Planning Department Staff Analysis

N1. Case No: A-25-1247491

Project Name: 521 Warren – Accessible home lot coverage

Requests: Application by Christian Patterson to request variance from Section 27-2.2.1 of the DeKalb County Zoning Ordinance to increase lot coverage from the allowed 35% to 57% to facilitate the construction of a single-family residence with wheelchair accessibility in the R-75 (Residential Medium Lot-75) zoning district and Scottdale Tier 2 Overlay.

BB-2219 FLOOR PLAN

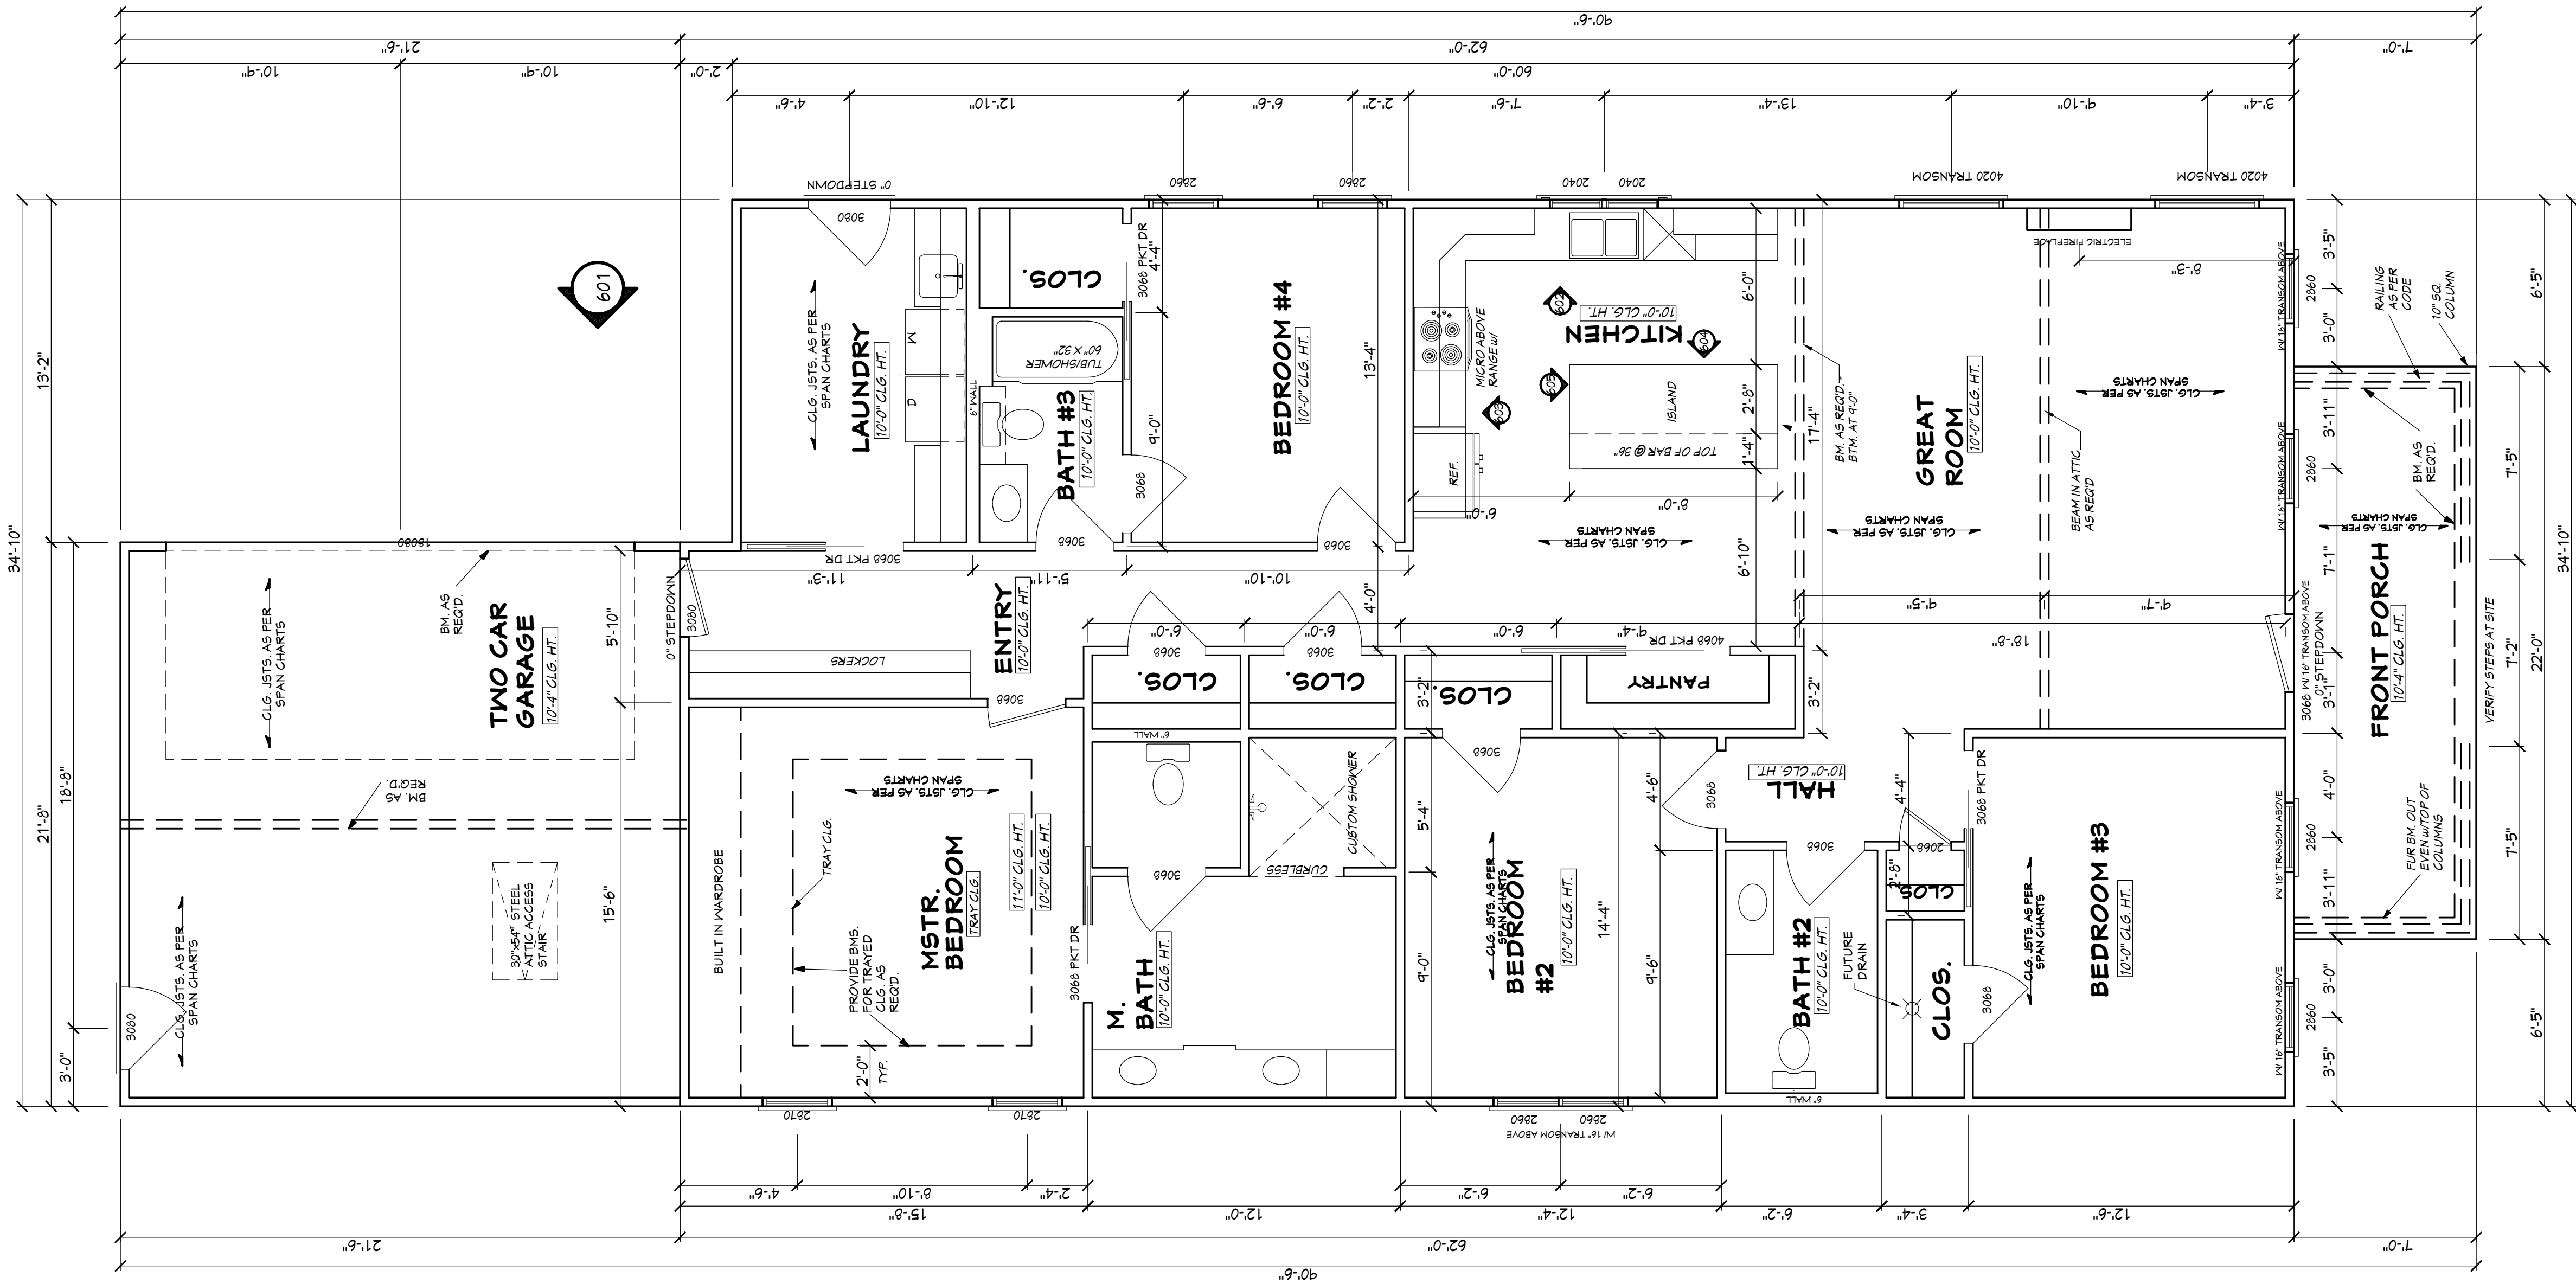
The proposed development exceeds what would reasonably be considered the minimum necessary to afford relief. The floor plan includes over five bedrooms and a total area of approximately 2,600 square feet, exceeding the 1,000 square foot minimum required in the Scottdale Overlay District. A proposed lot coverage of 57% appears to go beyond the minimum necessary to afford relief.

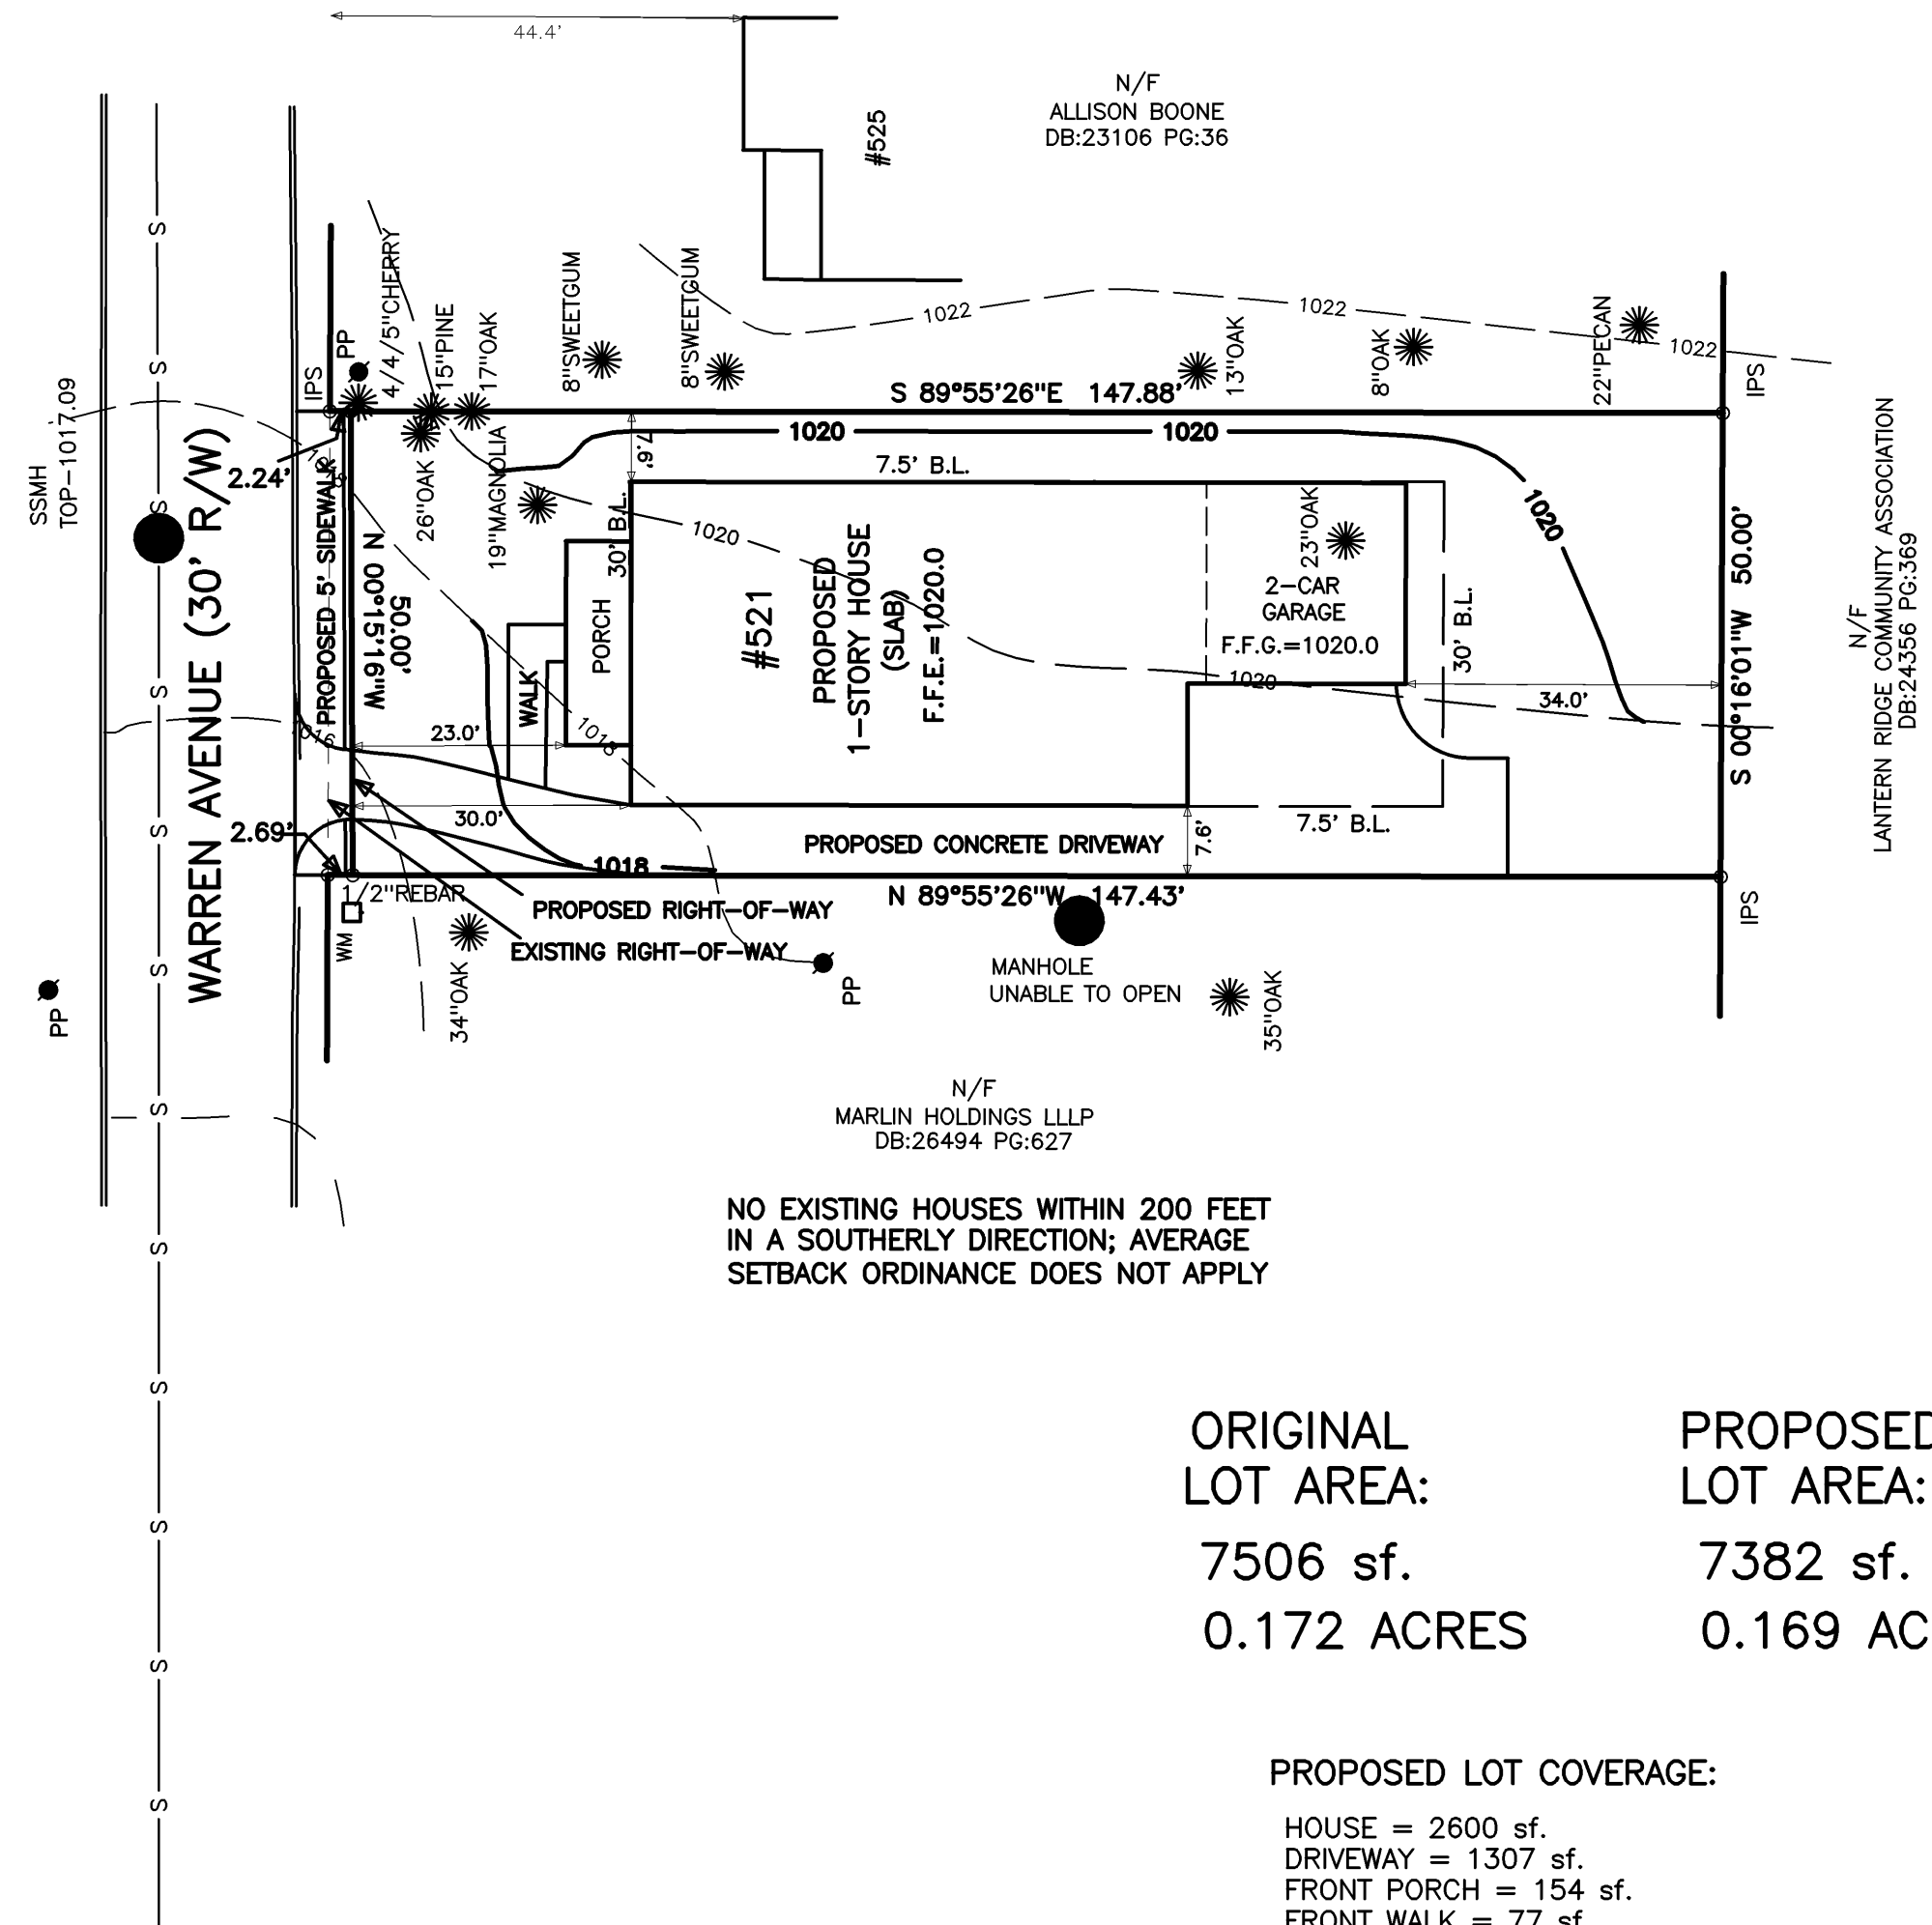
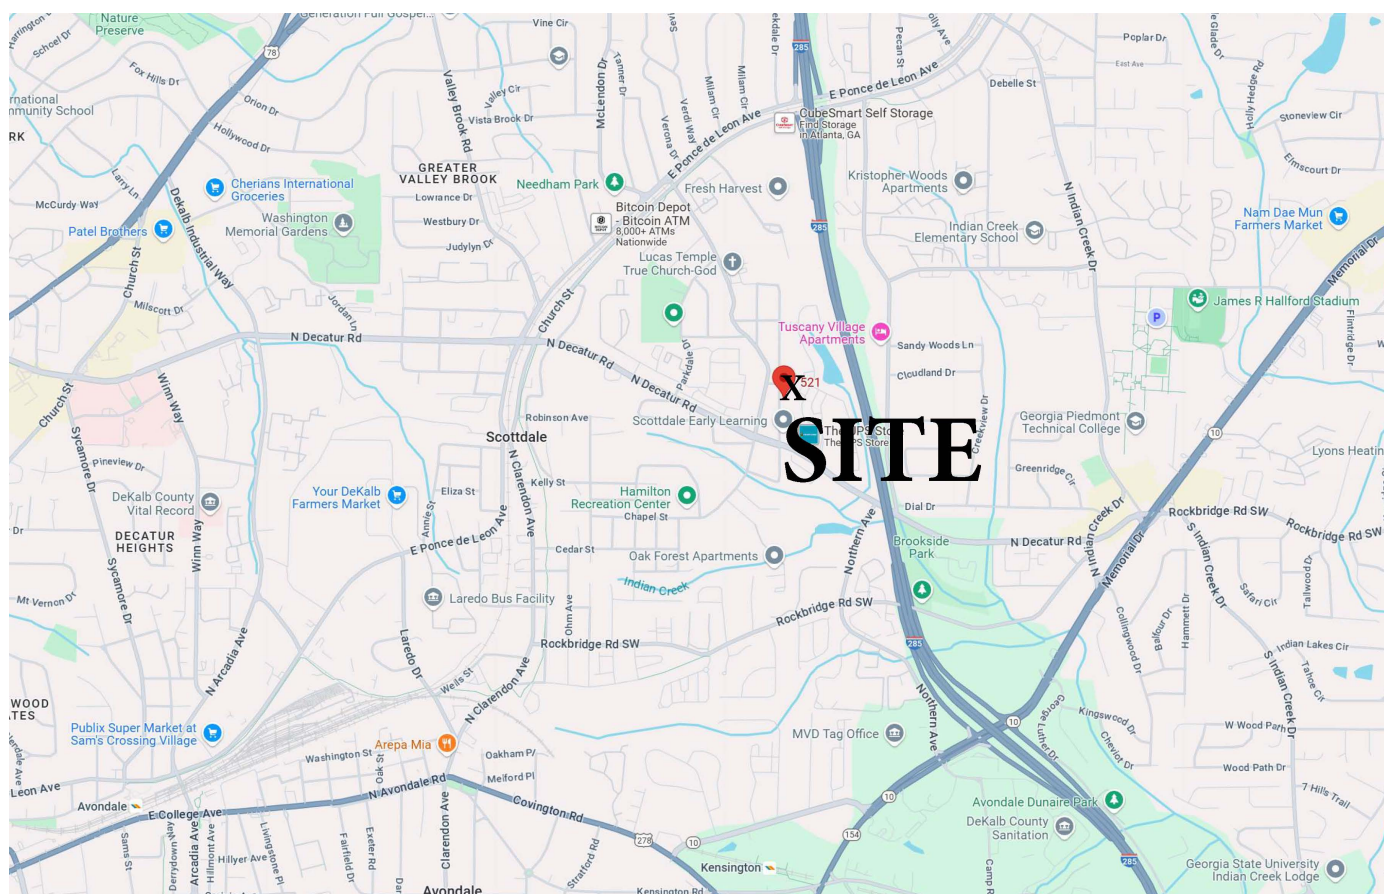
While the letter of intent estimated a 6.06% deviation from the lot coverage standard, staff review of the submitted plans confirms a proposed total lot coverage of 56.06%. This figure far exceeds the allowable maximum under current zoning and overlay provisions. As such, the variance represents a significant departure from both the numeric standards and the broader planning objectives of the overlay. The case emerges in a part of the county where reinvestment is active and where consistent application of overlay standards remains essential for maintaining neighborhood form and scale.

A revised proposal featuring a reduced footprint and additional pervious surfaces may warrant reconsideration. Any future submittal should include updated calculations, a clarified floor plan, and a design more closely aligned with the goals of the Zoning Ordinance and the DeKalb County Comprehensive Plan.
